SAFER BAY NOP COMMENT LOG

Re: 2022040504, Strategy to Advance Flood Protection, Ecosystems and Recreation along San Francisco (SAFER) Bay Project, San Mateo County

Thank you for the opportunity to attend the scoping meeting and provide scoping comments on the Notice of Preparation for the San Francisquito Creek Joint Powers Authority's (SFCJPA) Strategy to Advance Flood Protection, Ecosystems and Recreation along San Francisco (SAFER) Bay Project.

Exhibit 5: Typical Cross-Section, EPA South of Bay Road (SFCJPA diagram)

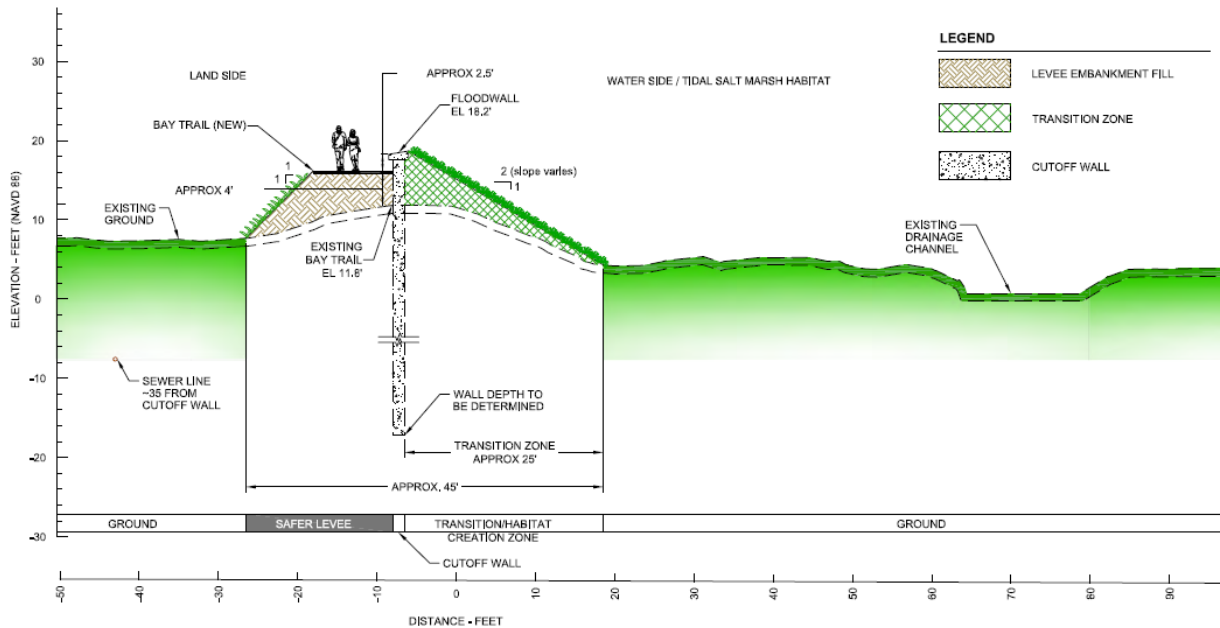
Further, based on the SFCJPA’s prior conceptual Cross-Section provided to Harvest, our design and engineering team had always assumed that a 2:1 slope would be designed and constructed along our property’s waterfront. Please see *Exhibit 5: Typical Cross-Section, EPA South of Bay Road* for this diagram provided by the SFCJPA. We submitted our Pre-Application in February 2020 and our Major Application in October 2021 to the City of East Palo Alto based on this conceptual Cross-Section provided to us by the SFCJPA and earlier conversations with SFCJPA staff members.

Exhibit 6 : Conceptual Cross-Sections of Integrated Floodwall and Transition Zone, Habitat Creation
NOP Figure 8: South of Bay Road, East Palo Alto

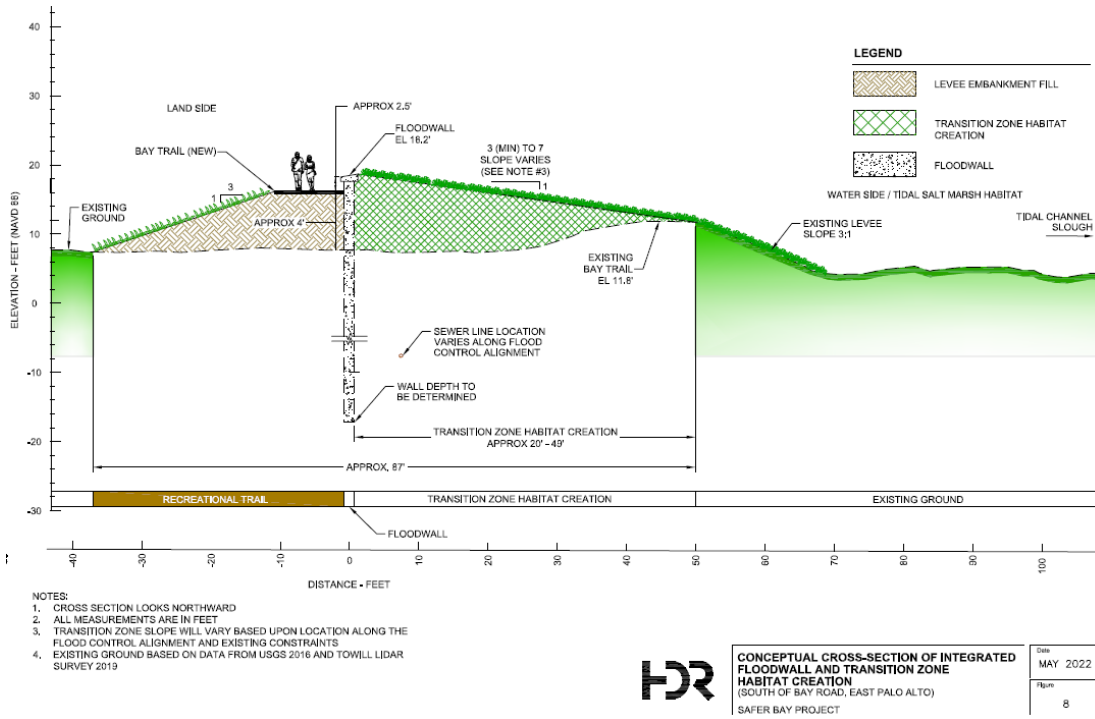
The NOP presents two (2) “Conceptual Cross-Sections of Integrated Floodwall and Transition Zone, Habitat Creation,” for the area south of Bay Road (*Exhibit 6: Figure 8 & Figure 9*). The Cross-Sections depicted are in the same location of The Landing project, as our properties extend south of Bay Road to south of Weeks Street. A slope of 3:1 (min) to 7:1 Transition Zone Habitat Creation is presented in these Cross-Sections, with a reference to Note 3 on the same page, which states: “Transition Zone will vary based upon location along the Flood Control Alignment and Existing Constraints.”

While we can appreciate the goal of maximizing this Transition Zone, it is critical to note that for portions of our site, anything greater than a 3:1 slope (and in some locations 2:1 slope) would eliminate the recreational and open space amenities that the community has expressed as critical for EPA’s waterfront. Please see *Exhibit 7: Levee with 7:1: Transition Zone*. As can be seen in this diagram, a 7:1 slope would extend inland into our property, by nearly 50 feet. If a transition zone of 7:1 were constructed along our property’s frontage, this would eliminate the possibility of the construction of the community’s children’s playground, ½ court basketball court, fitness area, picnic benches, BBQ areas, outdoor seating and the viability of future retail along that frontage. There would simply not be adequate room to construct these amenities. Additionally, the emergency vehicle access road that curves down from the end of the Weeks Street cul-de-sac would also would not be able to be constructed, which would create severe fire and emergency vehicle access problems. Others of The Landing’s amenities would also be drastically reduced in size, such as the project’s public plazas, and grassy amphitheater lawns, and waterfront seating areas.

Exhibit 7: Levee with 7:1: Transition Zone

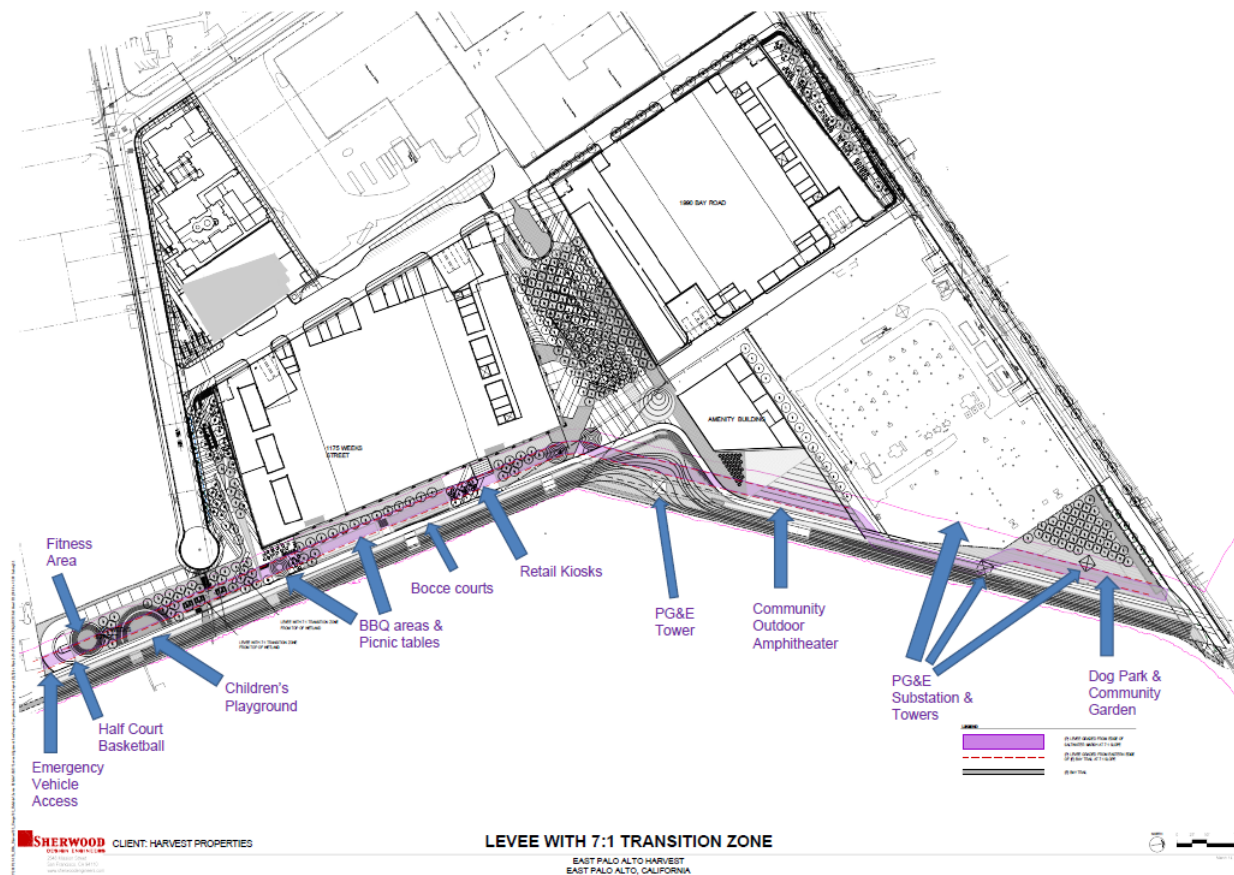
Note that the purple band in the Exhibit above represents the location of a 7:1 levee (including the Bay Trail), and, how far this would infringe into Harvest’s property.

Figure 3 from the NOP shows a levee with an 84-foot base extending from the edge of Hacker Way west into Ravenswood Slough.

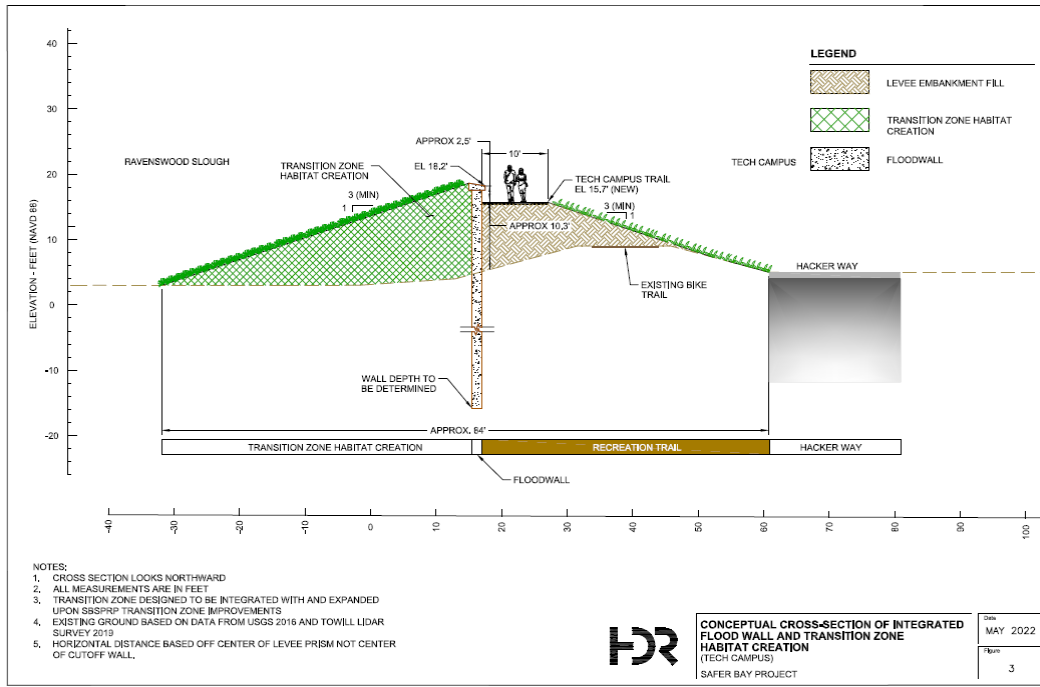
The NOP does not provide information on potential Project impacts to the salt marsh habitat in this section of Ravenswood Slough; however, using the figures provided in the NOP (Figures 1,3 and 4) it is clear that there is a potential for loss of salt marsh along 1.25 miles of Ravenswood Slough from the proposed Project levee.

- ★ For each alternative considered in the EIR for this reach, even at the program level, there must be specific locations and acreage provided for any wetlands and waters that could be temporarily, permanently, directly and indirectly impacted from the Project. The types of impacts and acreages of impacts should be provided in a table – (e.g. temporary, permanent, direct, indirect, habitat type, acreage).

Current conditions showing convergent shorelines (yellow line) of Ravenswood Slough going inland (north to south).

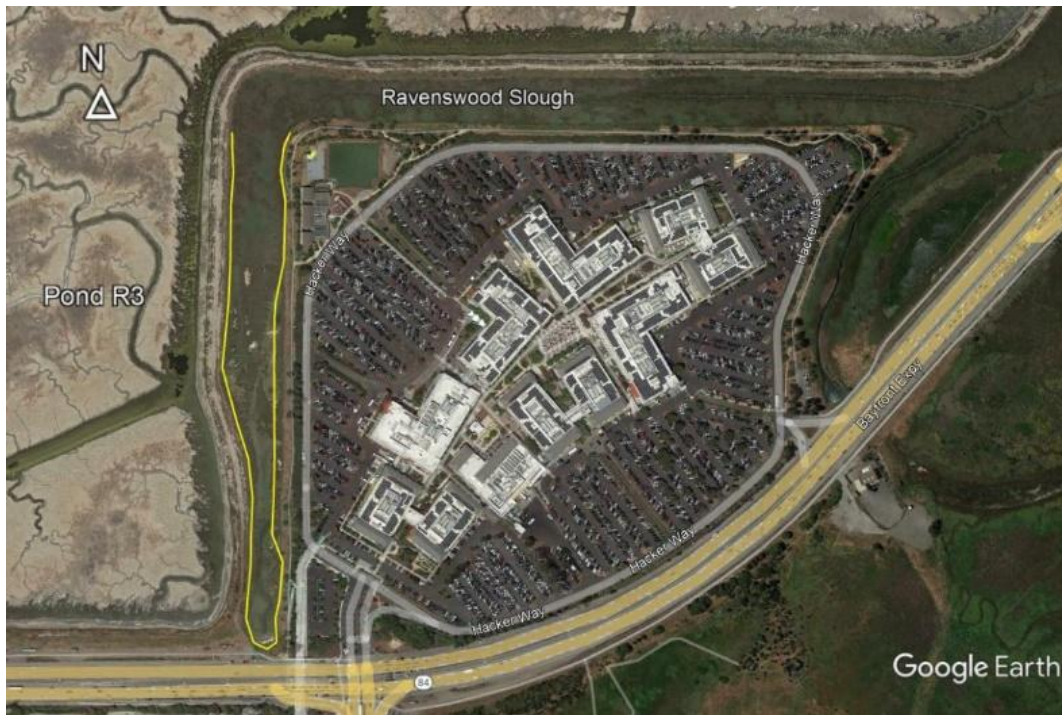
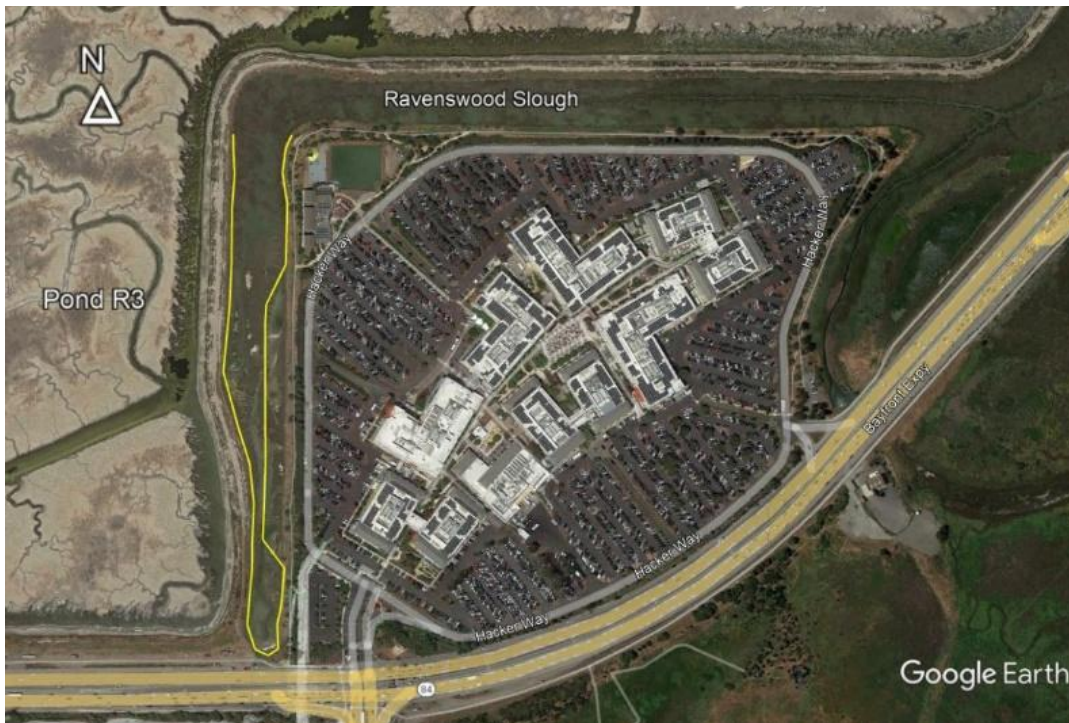
Converging shorelines increase tidal amplitude towards the landward end of enclosed estuaries⁶. Without knowing the extent to which a proposed levee may encroach into Ravenswood Slough, thereby increasing the convergence of the shorelines, it is not possible to determine what impact increased tidal amplitude may have on the structural integrity of the Pond R3 levee across the slough (even without sea level rise) that protects habitat for shorebirds and breeding western snowy plover from inundation.

Below are three Google Earth overlays showing approximate shoreline locations in Ravenswood Slough under different conditions: 1) current, 2) with an 84-foot wide levee base along the perimeter of the tech campus and 3) with a 117-foot wide levee base. Shorelines are estimated from the location of saltmarsh vegetation on the Google Earth image and field observations. The shoreline realignment drawn in the second and third figures is limited to levee sections where Hacker Way parallels Ravenswood Slough because the NOP only provides information for the proposed levee relative to Hacker Way, the perimeter roadway on the tech campus.

Ravenswood Slough shoreline with base of 84-foot levee extending west from Hacker Way, showing increased convergence of the shorelines.

Ravenswood Slough shoreline with base of 117-foot levee extending west from Hacker Way, showing increased convergence of the shorelines.

Figure 16 from the Feasibility Report showing the Option 1 floodwall with a greatly reduced Project footprint. Ravenswood Slough is on the left.

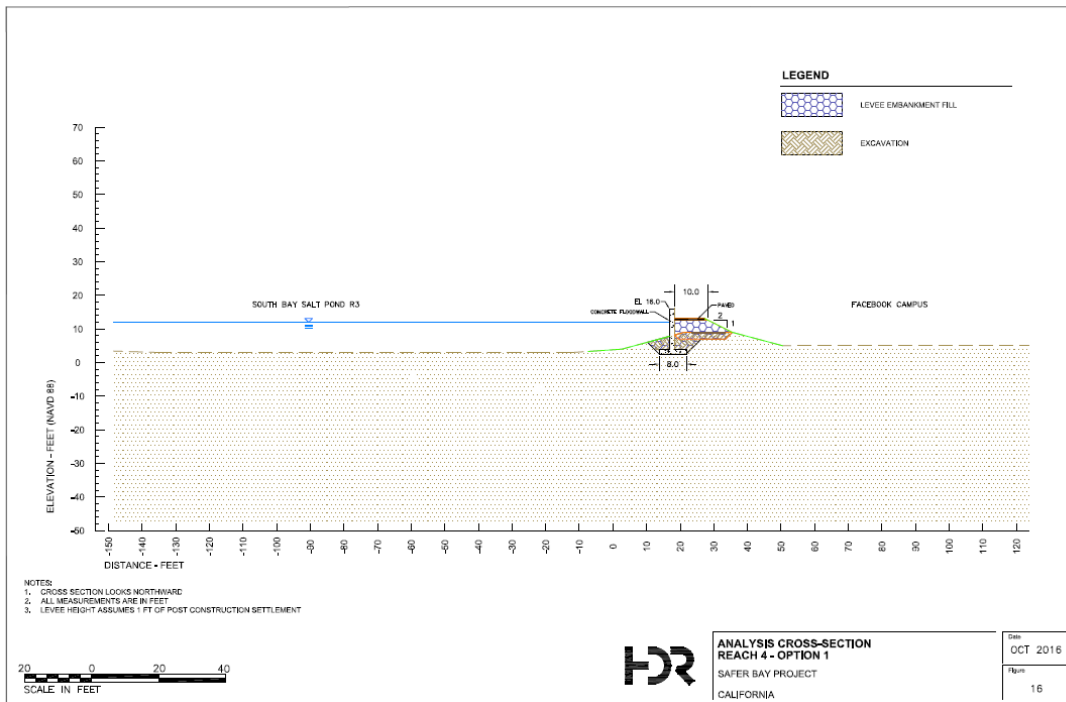
- ★ In order to avoid or minimize impacts to the Ravenswood Slough wetlands and endangered species, the Project should reconsider the Feasibility Report’s Reach 4, Option 1 levee shown in Figure 16 below, or another levee design that eliminates any permanent fill in Ravenswood Slough.
